Our Reference: NSW211526

**Re: Nepean Hospital Redevelopment Project - Stage 2
SSDA Response Letter – Civil Works**

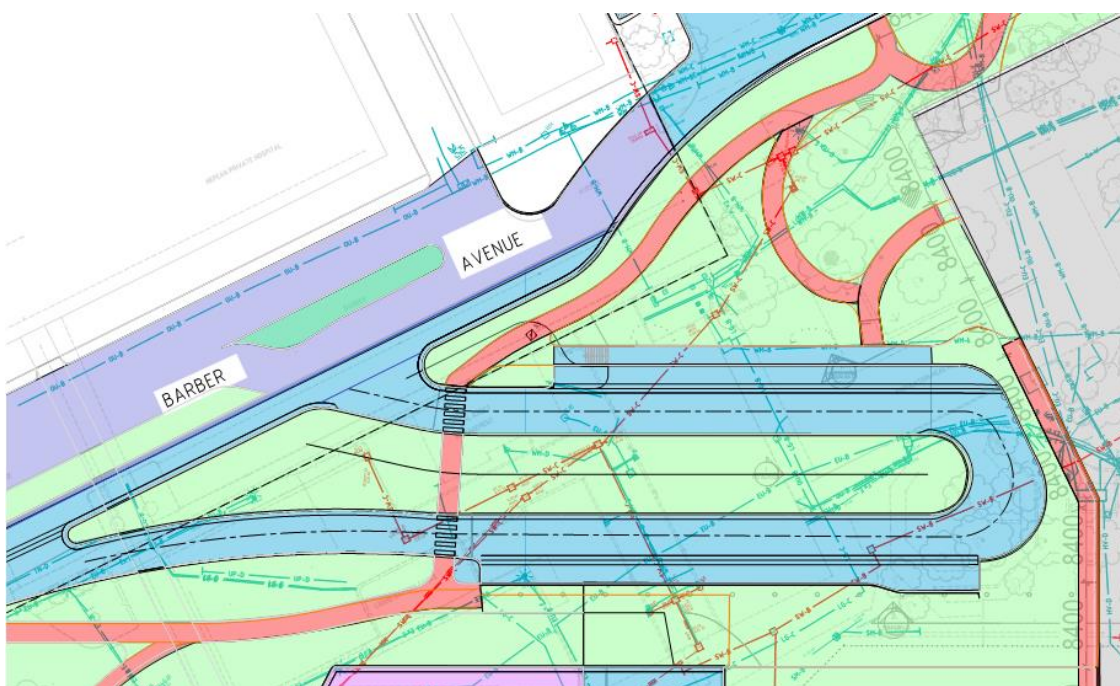
Penrith City Council's major Civil comments to the SSDA design relate to the removal of existing Barber Ave on-street public parking and the proposed Hospital intersection configuration off Barber Avenue being a Y-shaped entry arrangement rather perpendicular, as shown in the image below.

Further consultation and engagement have been held with Penrith City Council on 29/03/22 and 13/04/22 to discuss the proposed alterations to the SSDA design to address these comments.

The project team has proposed the below reconfiguration of the front entry layout as an outcome of these discussions. This revised layout is intended to provide perpendicular entry and exit points to Barber Avenue and reinstate 22 of the public on-street lost due to the development, as requested by Council, whilst reducing the impact on the amenity front entry amenity of the Hospital front entry drop off. Further information regarding the parking response can be found in the Traffic Engineering response letter completed by PTC.
